Urban Design Consultation

Proposal: Discharge of conditions 3 (Materials), 4 (Architectural Details), 5 (Landscaping), 6 (Landscape Management), 7 (Tree Protection Plan), 8 (PEA and Ecological Design Strategy), 9 (Foul and Surface Water), 15 (Traffic Management Plan), 16 (Cycle Store), 17 (Bin Store) and 18(Archaeology)- Partial Discharge of 25/00393/S73	**Location: Agricultural Buildings Washingley Farm Green End**
Case Officer: Charlotte Dew	**Application: 25/80119/COND**

This application follows an earlier approval of Conditions C3, C4, C5, C6, C8, C9, C13, C16 and C19 of the 22/00950/FUL application (24/80360/COND) and relates to the 25/00393/S73 application.
Comments in red text seek amendments / further information.

Figure 8.5 Plan of store for two cycles using wall fixings.

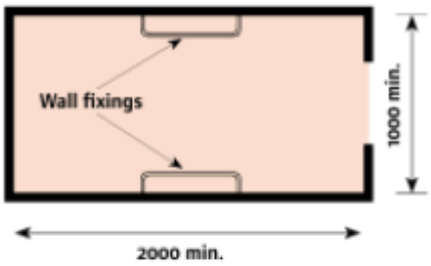
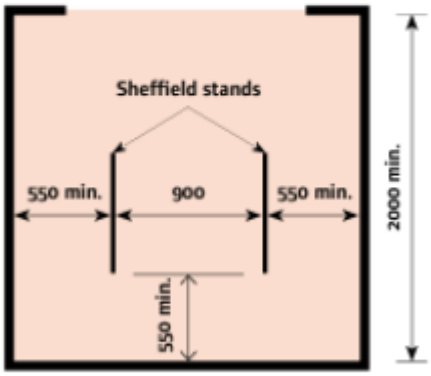
The cycle stores measure 1828mm x 1197mm with doors on the long elevation. Whilst these are accepatble for the 3 bed Plots 2, 3 and 4 where 3 bikes could be stacked against one another, larger stores should be specified for 5 bed Plot 1 and 6 and 4 bed plot 5 to provide sufficient capacity to accommodate 1 bike per bedroom in accordance with Local Plan Policy LP17. As per the previous 24/80360/COND approval, larger 2m x 2m cycle stores should be provided for these units. Revised Bin and cycle stores plan dwg 2024.09.201 Rev A now specifies two store sizes: smaller 1828mm x 1197mm stores for the 3-bed Plots 2, 3 and 4 and larger 2000mm x 2000mm for the 5-bed Plots 1, 5 and 6. Support.

See recommended sizes of cycle stores to accommodate 2 and 4 bikes contained in Manual for Streets:
